METRO FLOOD DIVERSION AUTHORITY

Thursday, January 26, 2017

Change Order No. 09

4th Street Pump Station and Gatewell - 2nd Street Floodwall South

Series HTF Standard Three Float Sensor

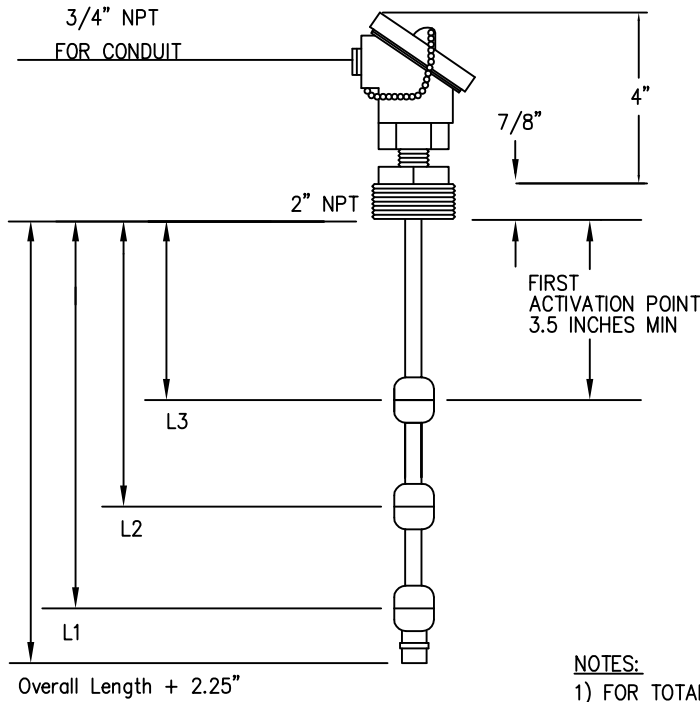
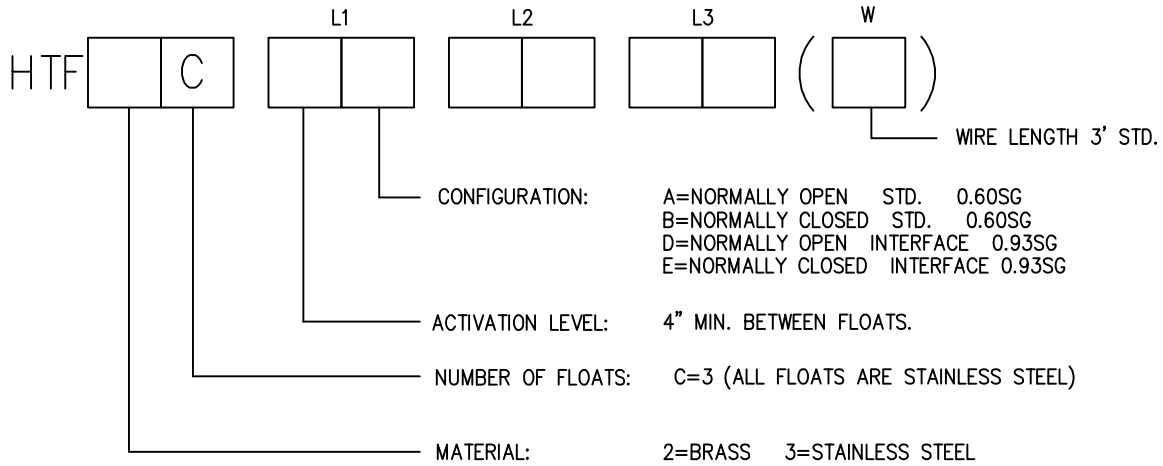
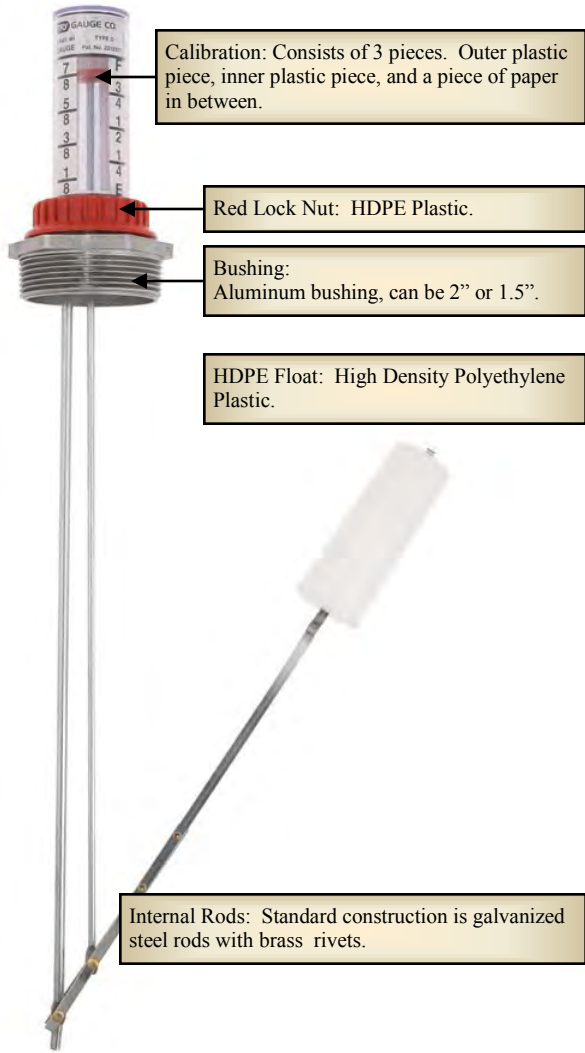
The level sensors will be added per the attached quote from Fusion Automation OPTION A. The proposed sensor information is also attached to this quote.

OPTION A: HTF 3 float stem sensor

- Only measures 3 set levels
- Electronic feedback
- Labor for Install

1. FUEL LEVEL SENSORS
Add \$1,906.80 to the Contract Price to accommodate additional fuel level sensors that will monitor the 25%, 50%, and 75% fuel levels in the generator fuel tank.
2. FLOODWALL COPING
Add \$4205.00 to the Contract Price for the contractor to furnish and install higher pitched wall coping for the floodwall south of 2nd Street.
3. TRASH RACK MODIFICATIONS
Add \$6,393.00 to the Contract Price to accommodate the installation of modifications to the trash racks.

Task: Trash Rack Adjustment

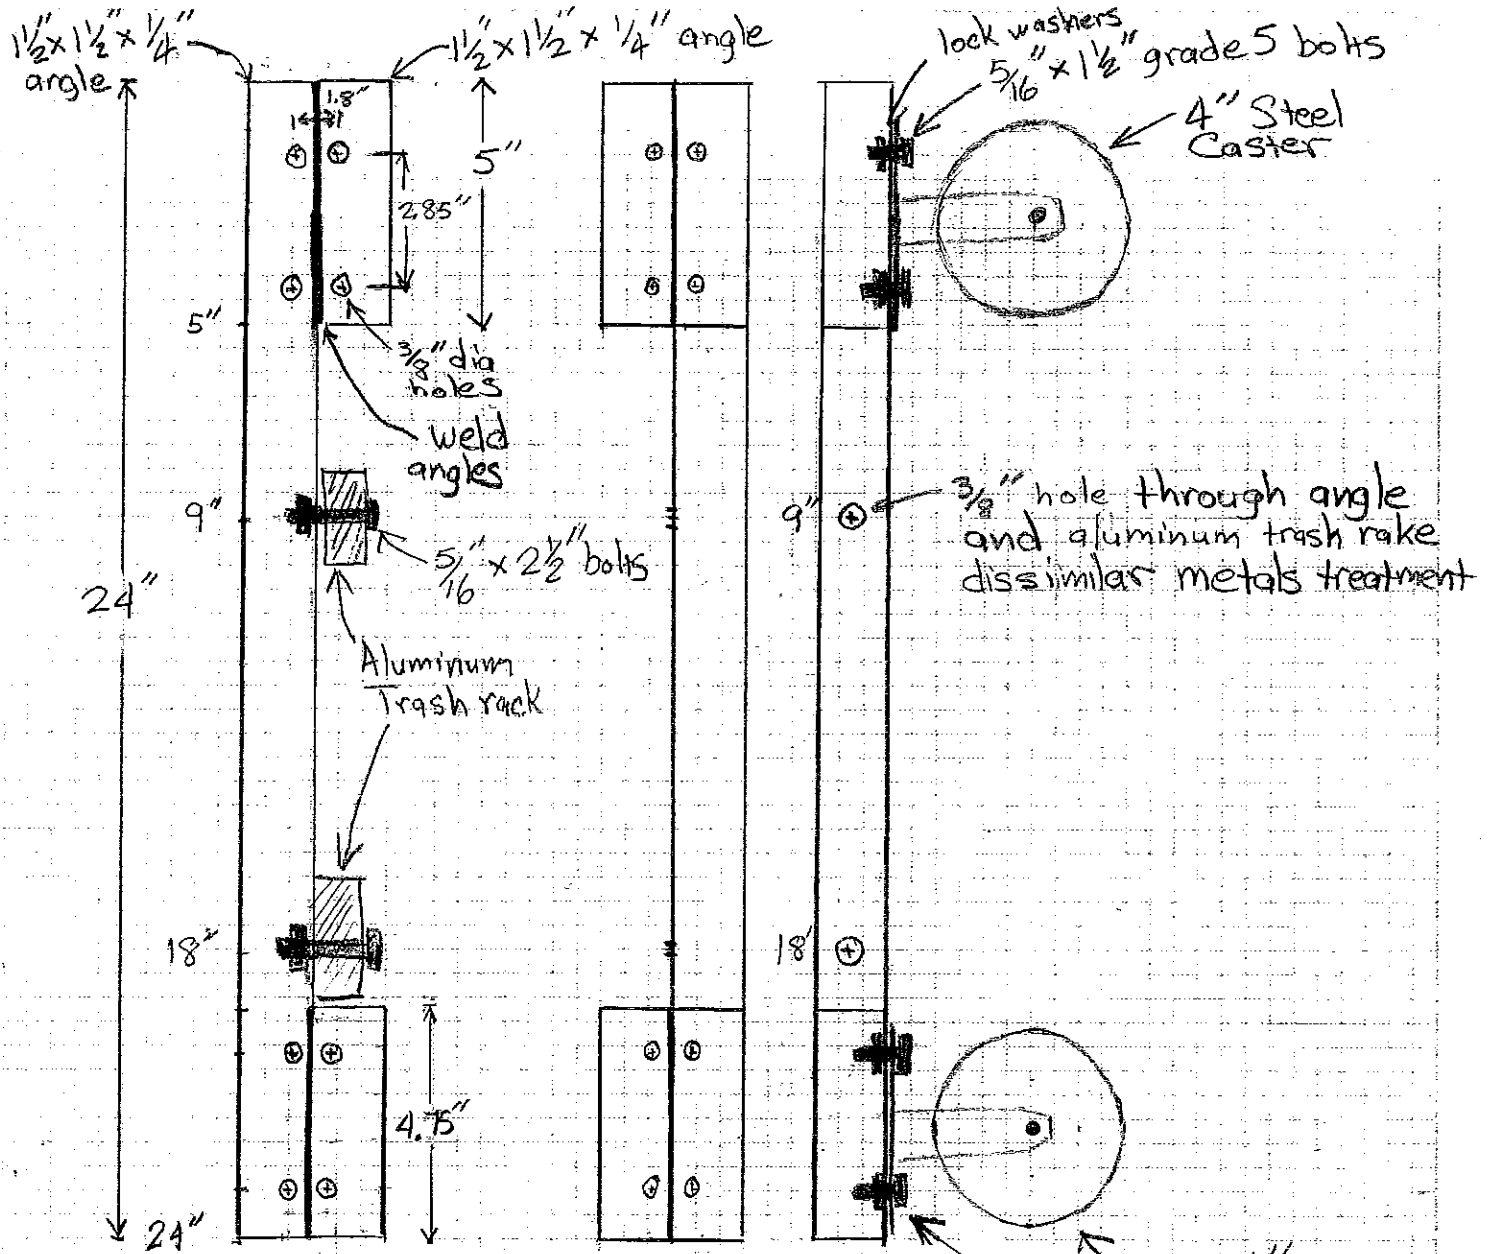
The attached cost is for a design change to the Trash Rack Rake System in the pump station. Glen Krogman with HMG requested the change so that the trash racks would operate smoother.

The trash rack rake modifications were requested by HMG to improve functionality. Glen Krogman with HMG provided a sketch dated 12-07-16 showing the changes and is the basis for our pricing. It is our understanding that the design was based on a prototype that operated in the field. This price includes materials, labor for installation, as well as labor to help Glen in the field with fitting his prototypes.

- Trash Rack Modifications.** The installed trash racks do not operate smoothly and jam frequently during operation. The Engineer, with assistance from the Contractor, has researched and developed a solution that includes fabricating and installing additional guide rollers on each of the trash racks. This change adds \$6,393.00 to the Contract Price to fabricate, install, and test the guide rollers. The Owner’s Representative and Engineer have reviewed this cost and found it to be reasonable.
